Proposal for Amendment to Regulation No. 27

(Advance-warning triangle)

The text reproduced below was prepared by the expert from CLEPA to clarify technical progresses; and, as the 66th GRE Session agreed resuming consideration of ECE/TRANS/WP.29/GRE/2011/46 from GTB (see ECE/TRANS/WP.29/GRE/66 para. 31; the modifications to the existing text are marked in bold for new or strikethrough for deleted characters.

Figure 1: SHAPE AND DIMENSIONS OF THE ADVANCE-WARNING TRIANGLE
AND OF THE SUPPORT

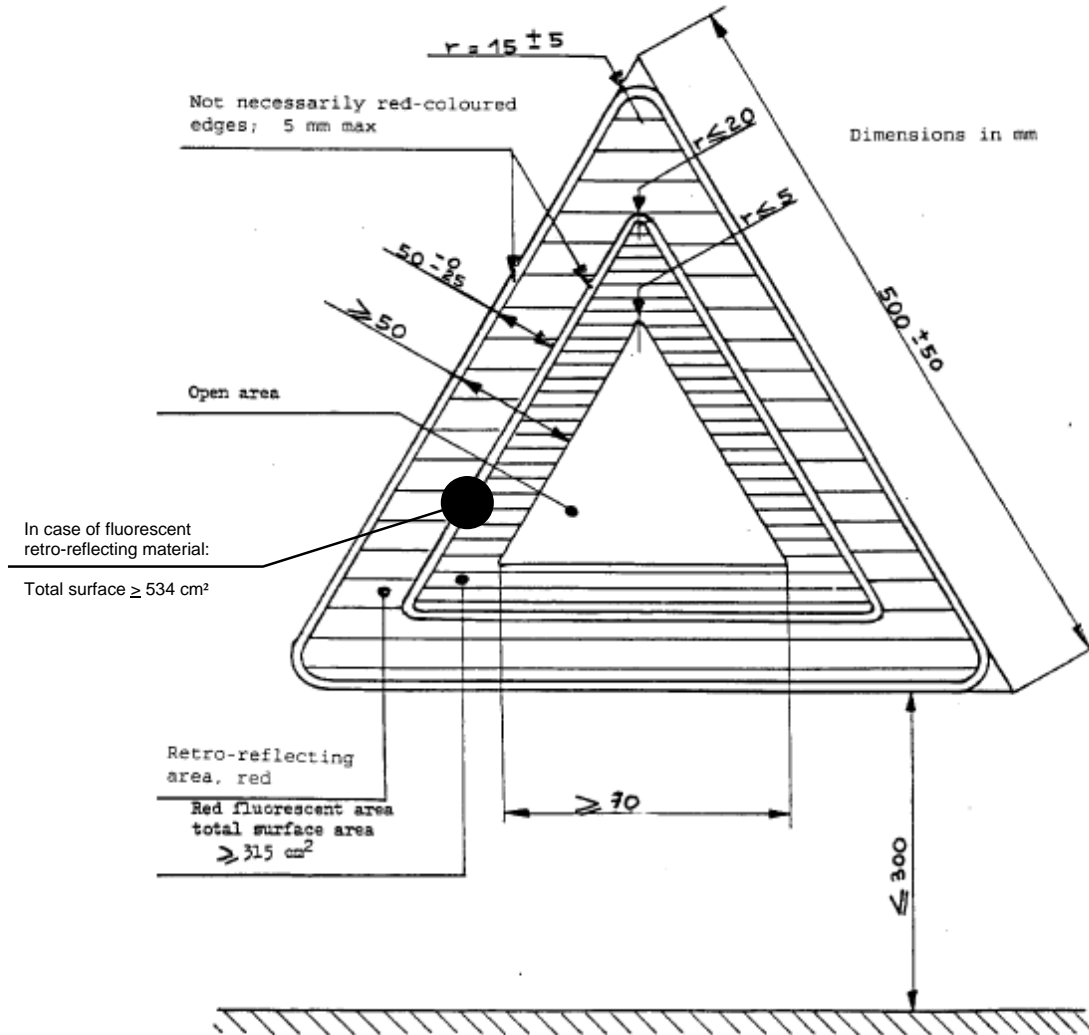
- 6.1. The advance-warning triangle shall be open at the centre and shall comprise a red border composed of an outer retro-reflecting strip and an inner fluorescent strip, the whole supported at a certain height above the surface of the carriageway. The open centre and the fluorescent and retro-reflecting strips shall be bounded by concentric equilateral triangular contours. **Alternatively, one fluorescent retro-reflecting strip may be used.**

- 7.1.1.2 The retro reflecting units shall be arranged along the edge within a strip of an unvarying width which shall be between 25 mm and 50 mm. **In case of fluorescent retro-reflecting material, the unvarying width shall be > 50 mm. When in use, its surface area shall not be less than 534 cm².**

This amendment would enable to combine the two separate optically active stripes of the advance warning triangle into one. Today the daytime visibility is provided by the fluorescent stripe, while the nighttime visibility is provided by the retro-reflecting stripe.

Combining both into one stripe will result in advance warning triangles with improved visibility and less material use. Warning triangles could be built more economically, lightweight and with better performance.
